# **A G E N D A**

## **Architectural Review Board**

**July 28, 2015**

3351 Wellington Avenue

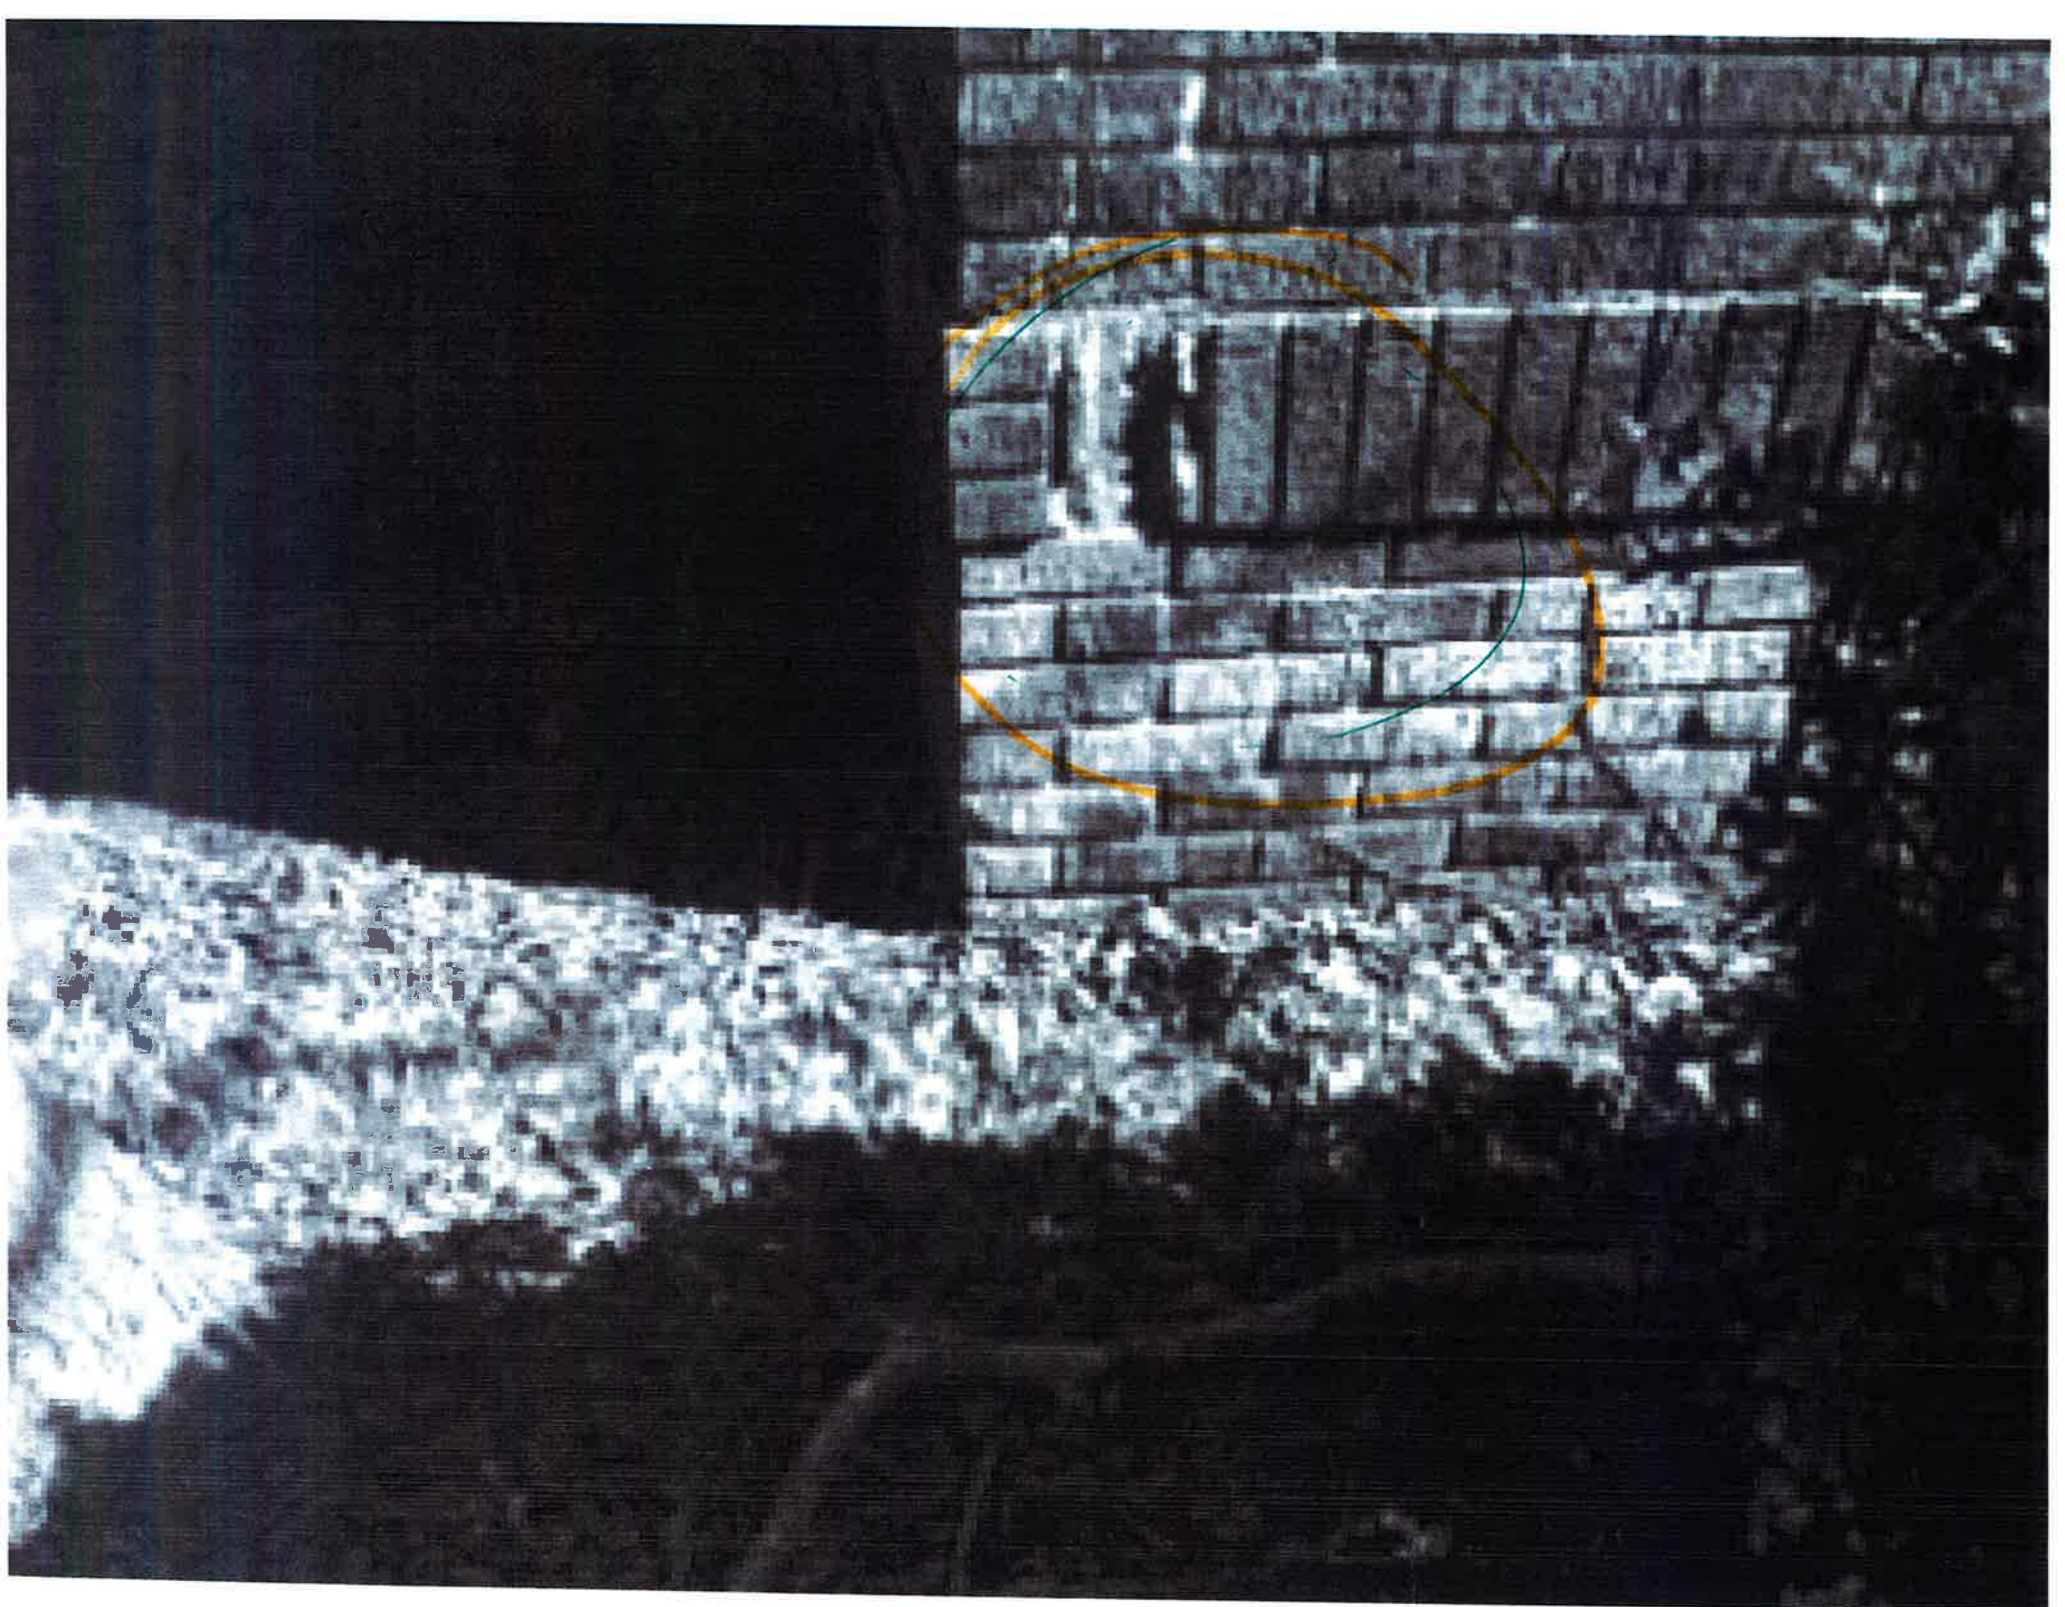
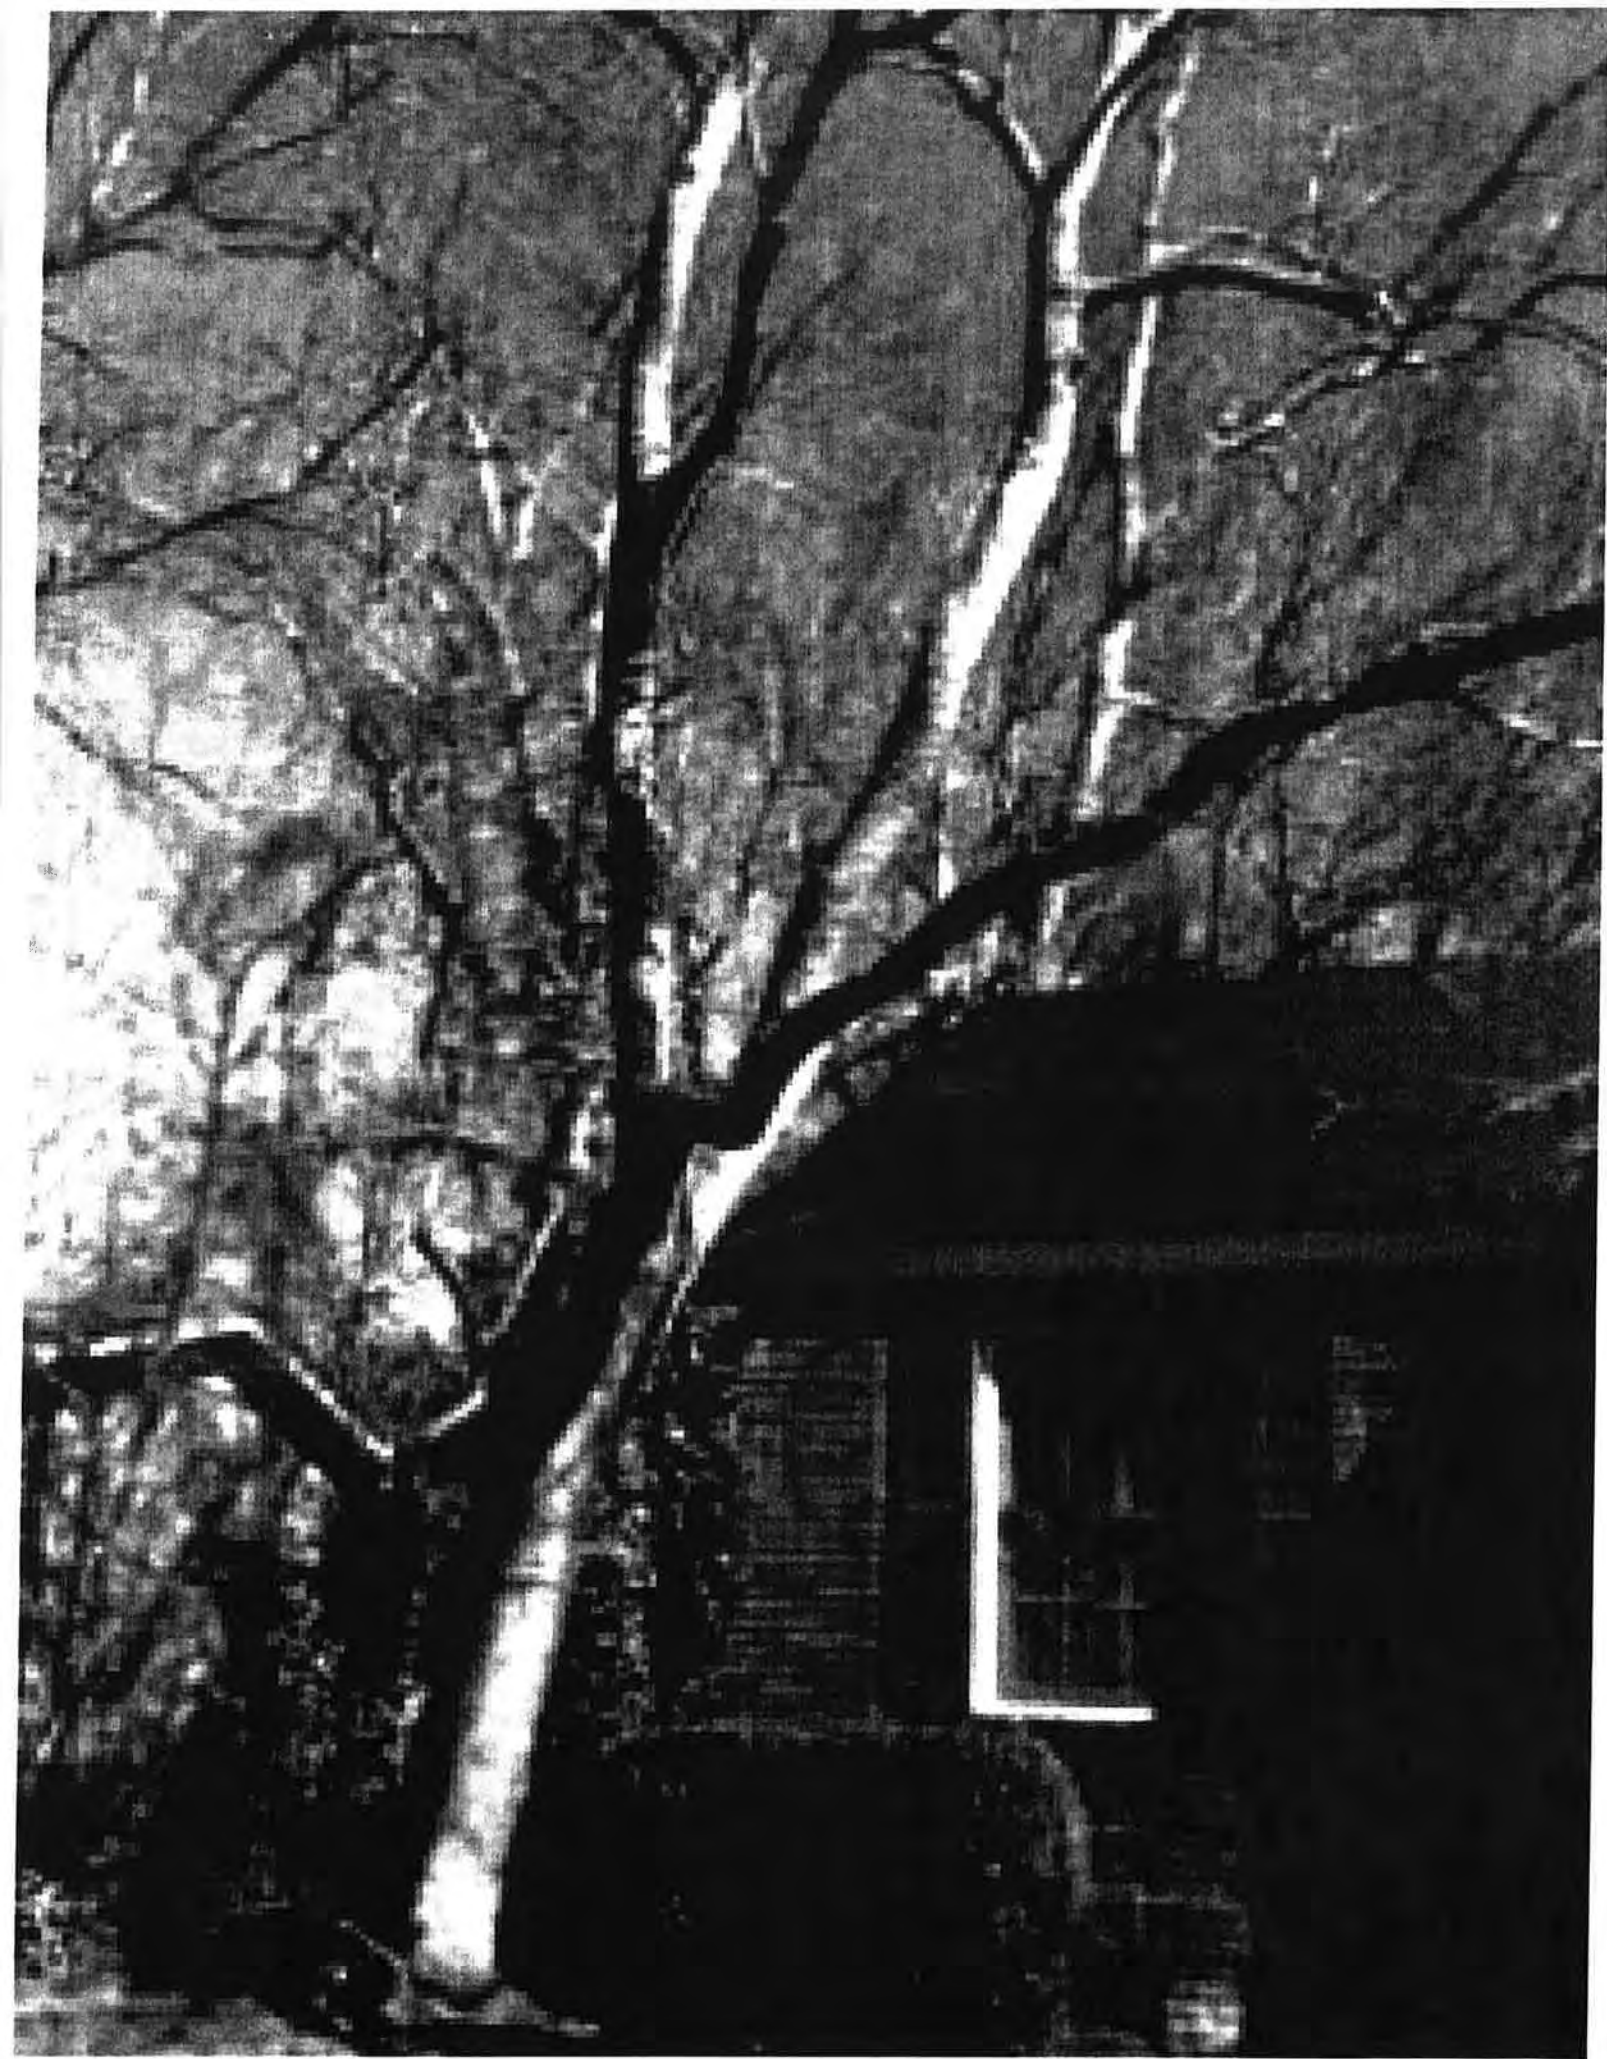
- Urban Forester recommends replacement.
